## ADDENDUM

**DATE:** April 8, 2012  
**TO:** Commissioners and Interested Parties  
**FROM:** South Central Coast District Staff  
**SUBJECT:** Agenda Item 26b, Wednesday, April 10, 2013, City of San Buenaventura Local Coastal Program Amendment No. SBV-MAJ-1-12

The purpose of this addendum is to add to Suggested Modification One (1) and findings for expansion of the designated view corridor and bird survey requirements, to replace Exhibit 5, and to address an inadvertent error.

Exhibit 5  
SBV-MAJ-1-12  
Location of View Corridor

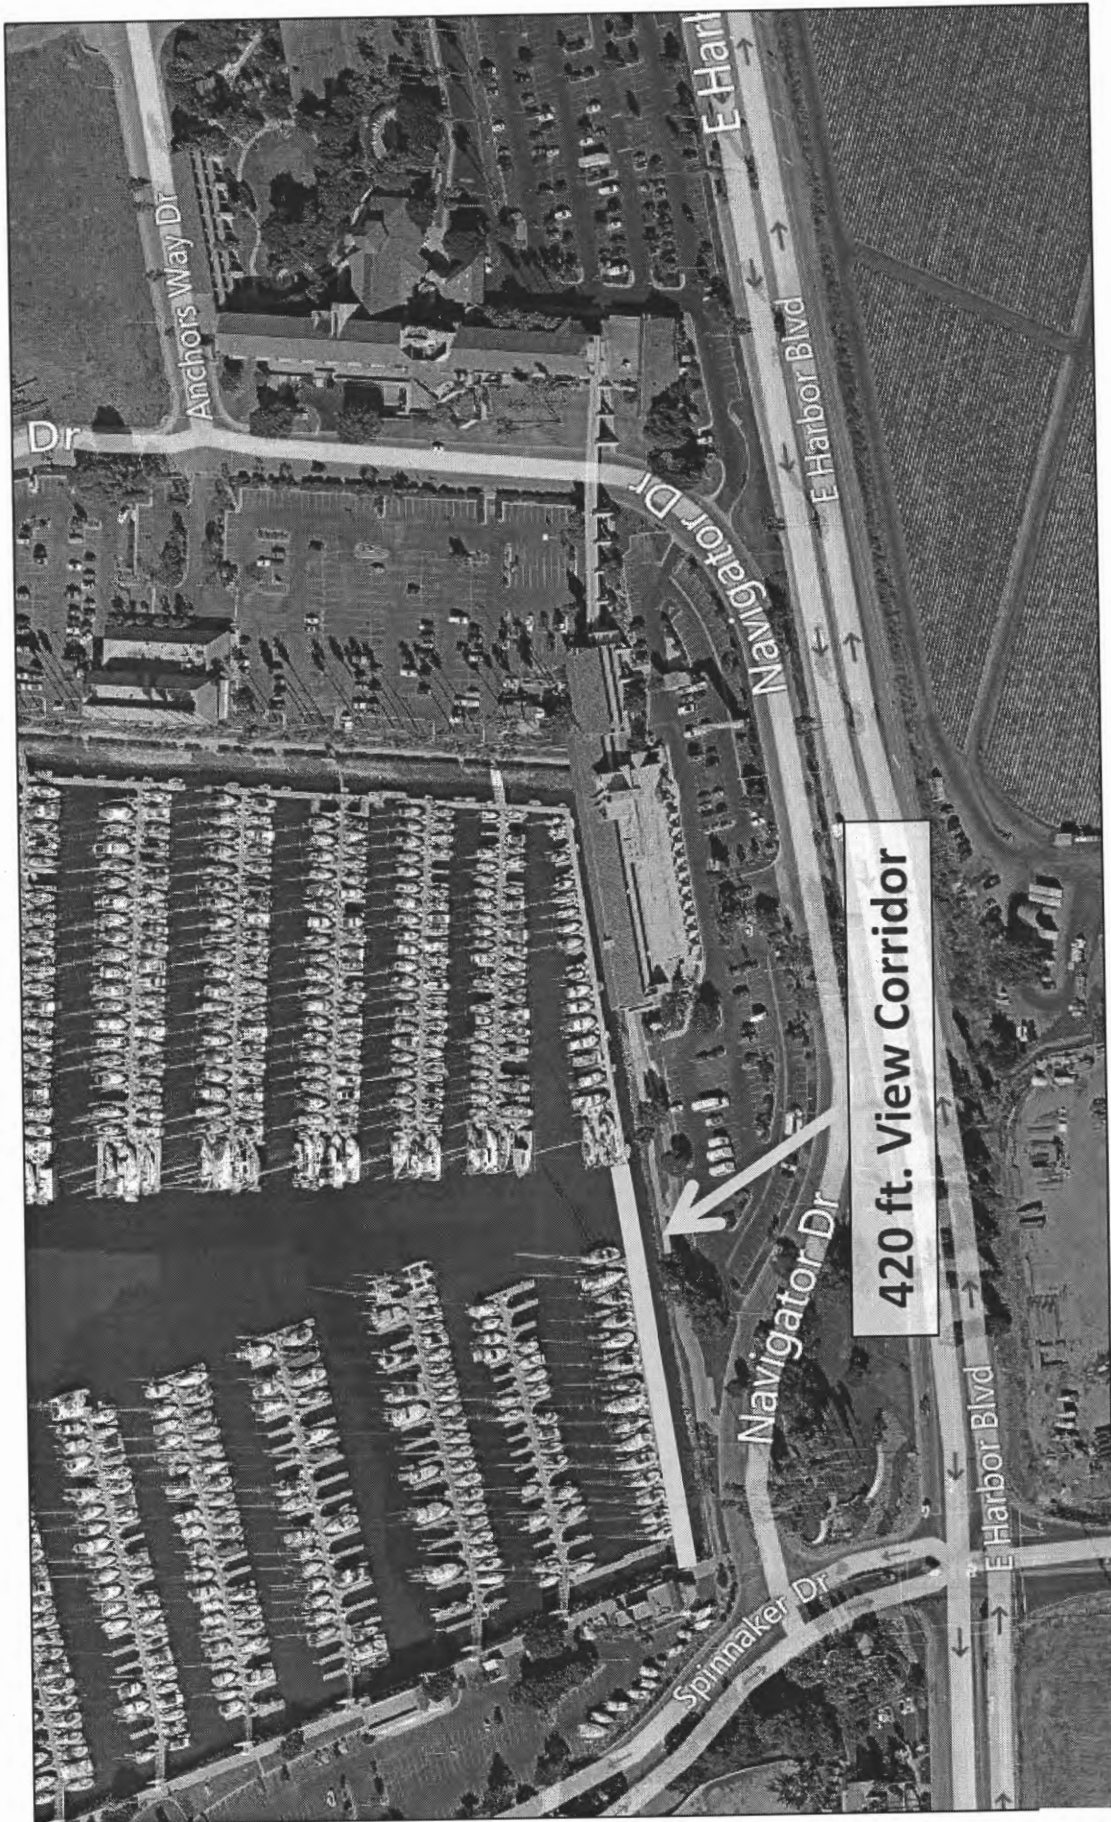
1. One continuous view corridor shall be maintained between Harbor Boulevard and Navigator Drive to the harbor waters, ~~from the southern terminus of Parcel One, beginning approximately 135 feet south of the existing boatel/hotel,~~ and continuing ~~north~~ south for approximately ~~217~~ 420 feet to Spinnaker Drive, as depicted on Map 4. 100 % of this view corridor shall preserve views of harbor waters. Parking lot(s) and low-lying landscaping (plant species with a maximum natural growth of less than 2 feet in height) may be permitted within the view corridor, but structures are prohibited. Existing vegetation within the view corridor that is over 2 feet in height shall be removed.
2. All structures shall be limited to three stories, not exceeding 45 feet in height.

3) Exhibit 5 of the March 27, 2013 staff report shall be deleted and replaced with Exhibit 5 included within this addendum, dated April 8, 2013.

**420 ft. View Corridor**
